RESPONSE TO THE REPLY FROM COUNCIL ON PLAN CHANGE 62

This is a response to the Council's reply to the Commissioner on the Interim Recommendation, on behalf of the Applicants to Plan Change 62.

Leeston Plan Change

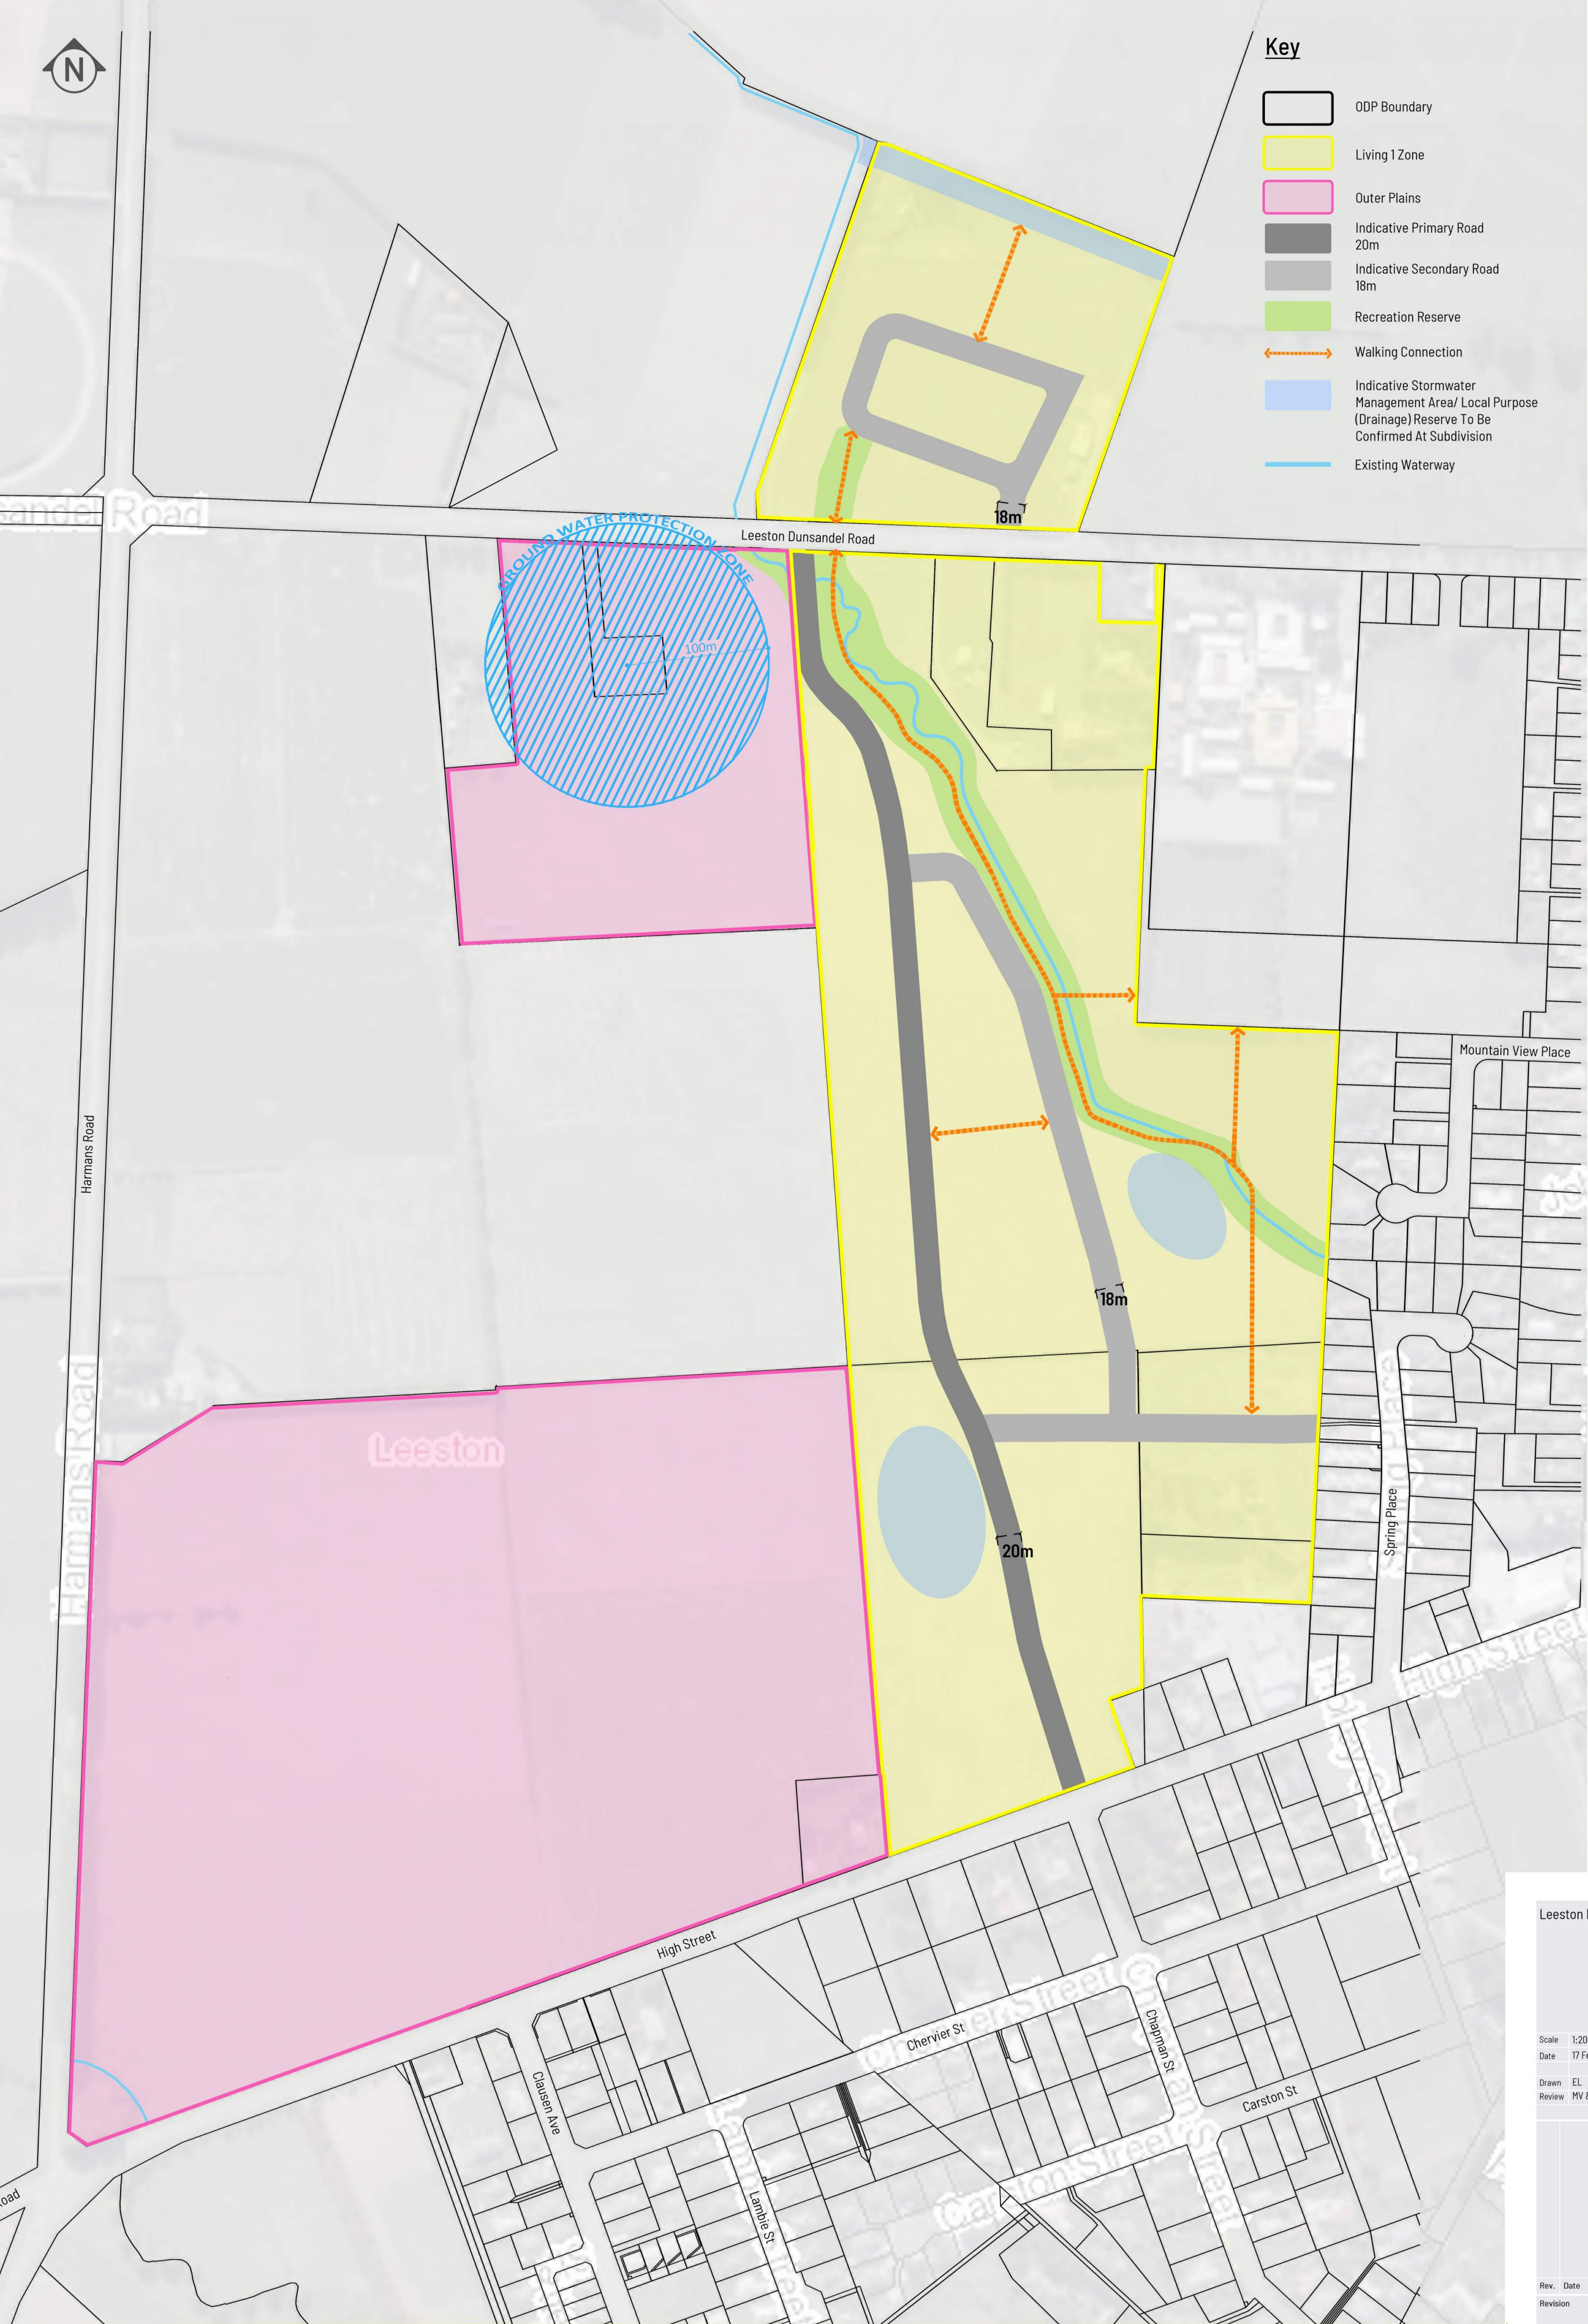
- Option 1: Showing the Landscape Buffer between the Outer Plains and Living 1 zone removed.
- Option 1A: Showing the Landscape Buffer between the Outer Plains and Living 1 zone removed as well as the inclusion of 149 High Street.
- The walking track to Leeston Dunsandel Road has been re-instated.
- It is noted there is no change to the stormwater detention basins for either Option.
